**Subject: FERC Project No. 96-045, Kerckhoff Hydroelectric Project
Proposed Study Plan, Study Plan Meeting Announcement,
and Response to Comments**

Pacific Gas and Electric Company
 Kerckhoff Hydroelectric Project (FERC Project No. 96)
 Response to Stakeholder Comments on the Kerckhoff Scoping Document, PAD, and DSPs

Table B-1: Response to Comments Received from the State Water Resources Control Board (State Water Board) on March 16, 2018

Figure GEO 2-2. Approximate Sediment Sampling Locations in Kerckhoff Reservoir.

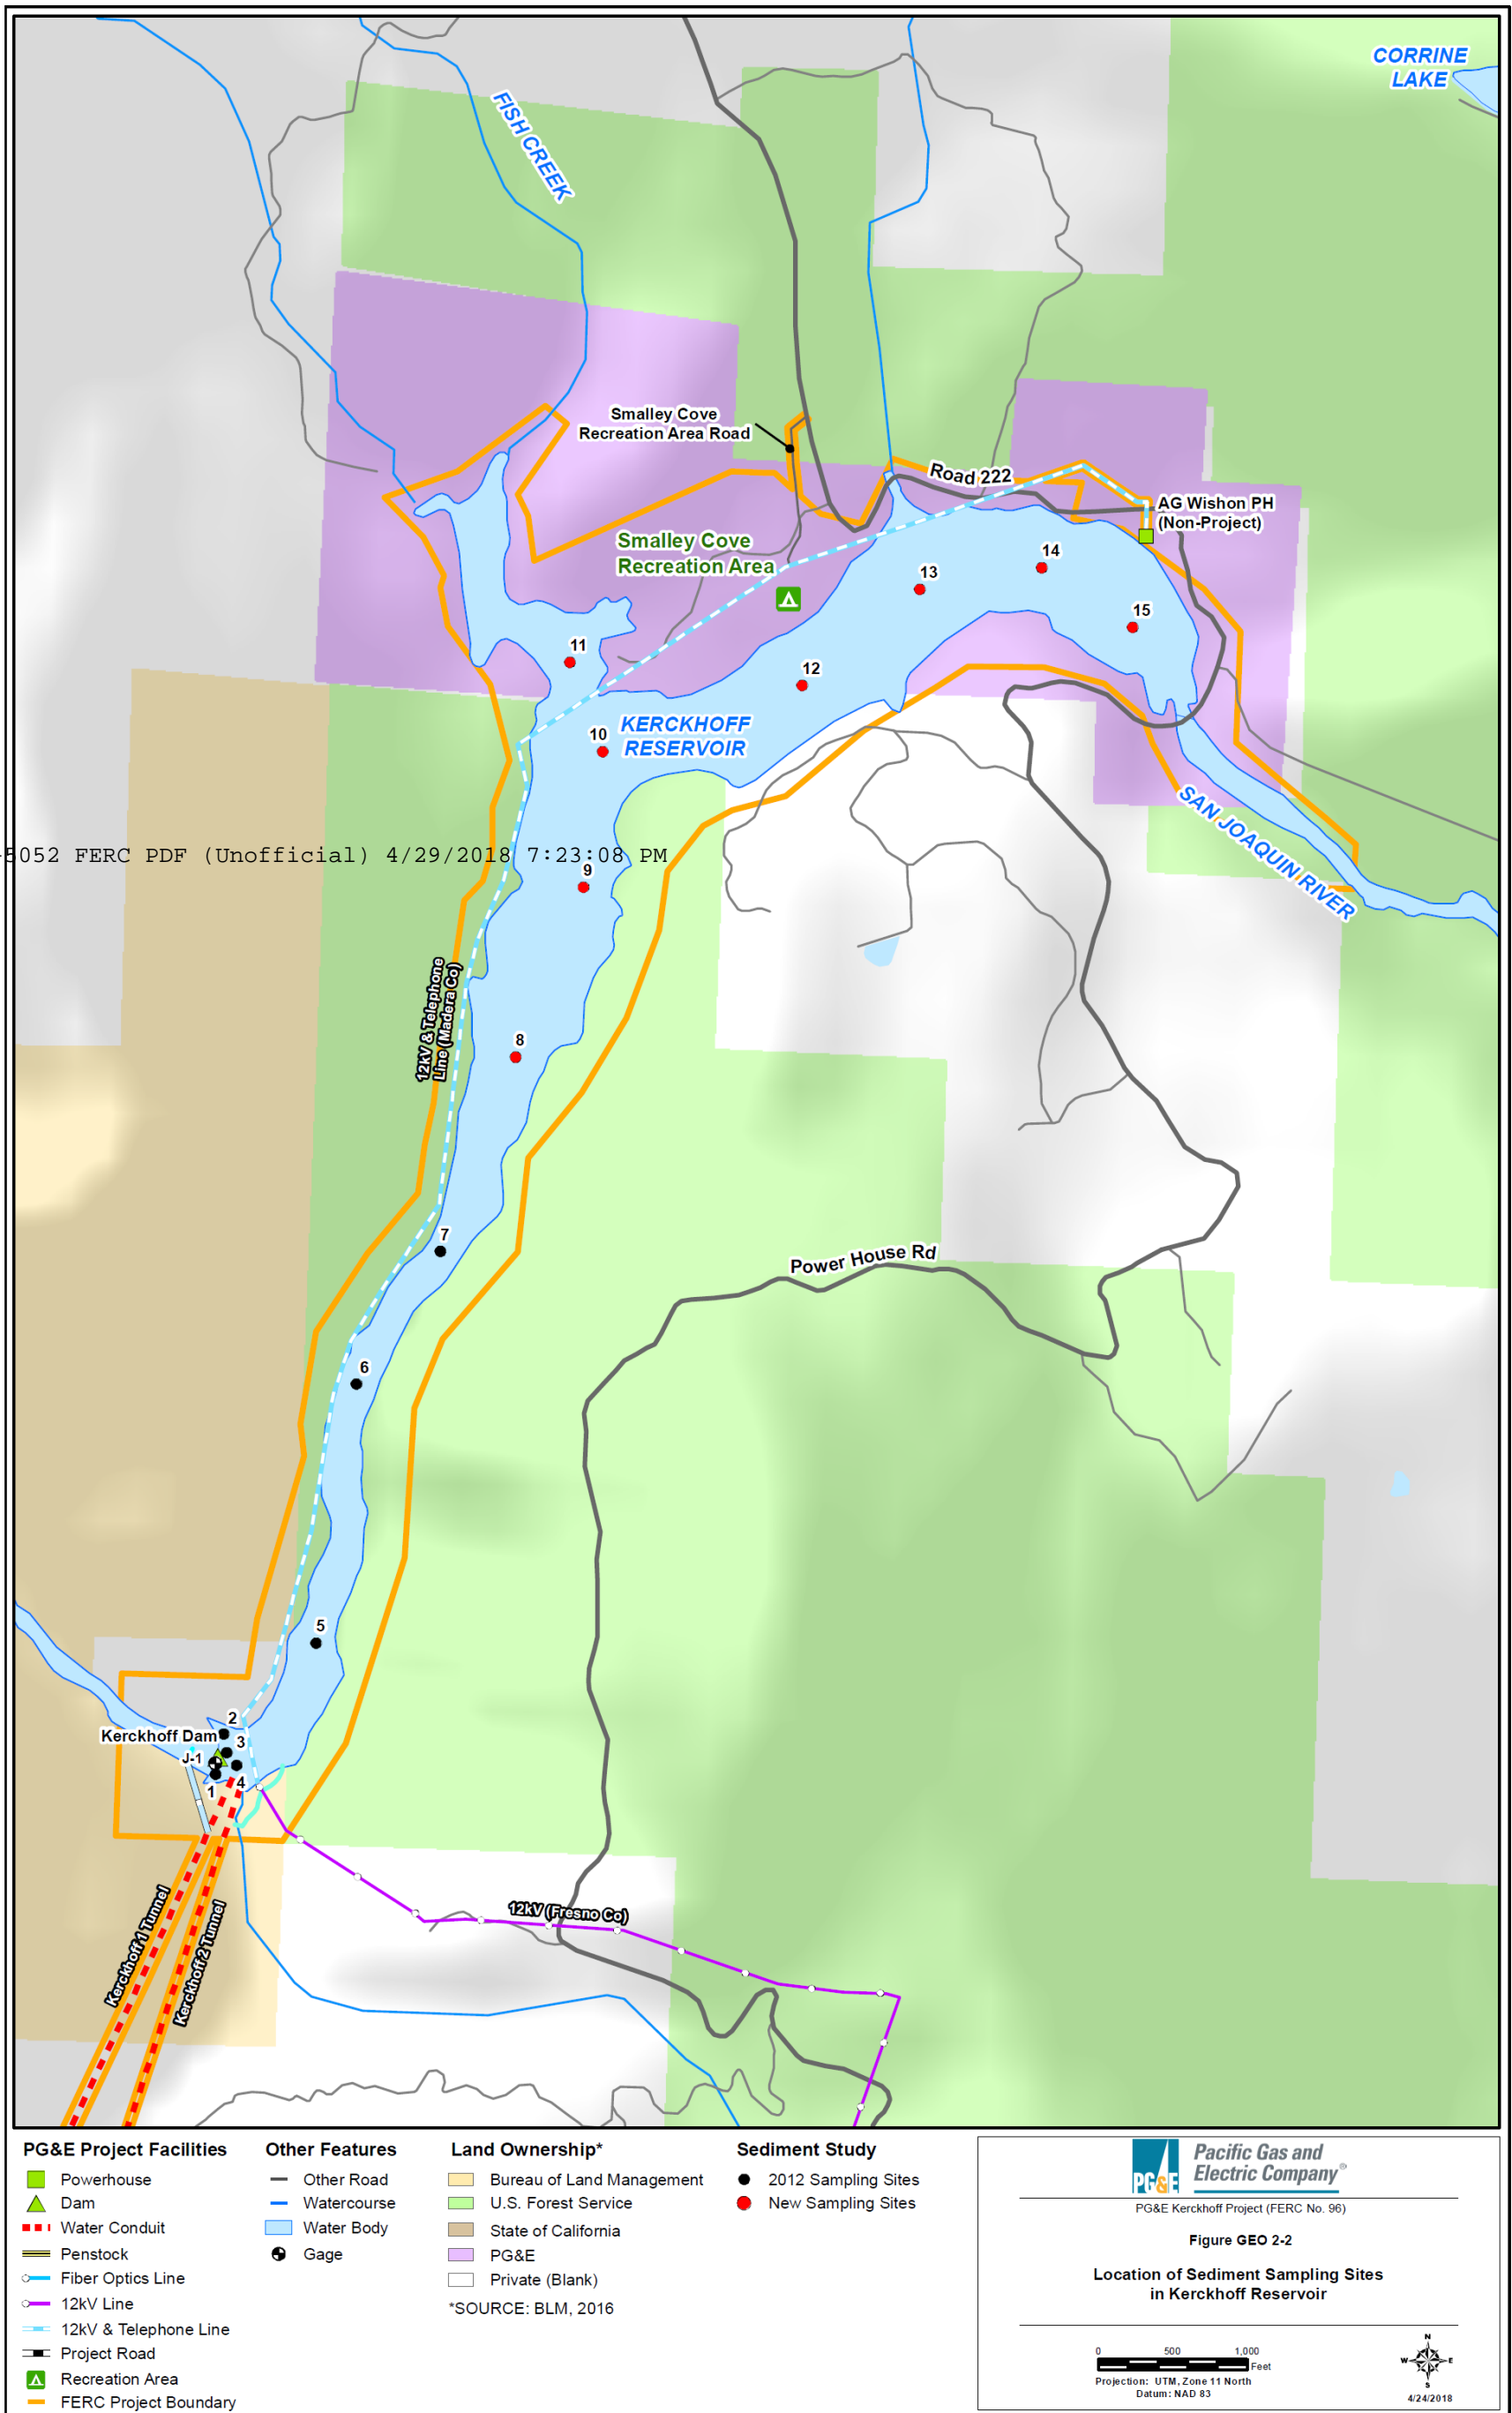
- An additional eight sites located throughout the reservoir will be used to provide further information on sediment in areas not sampled in 2012, especially shallower areas and areas representing potential transport pathways for incoming sediment. The approximate locations for the additional sampling sites (numbered 8 through 15) are shown in Figure GEO 2-2.
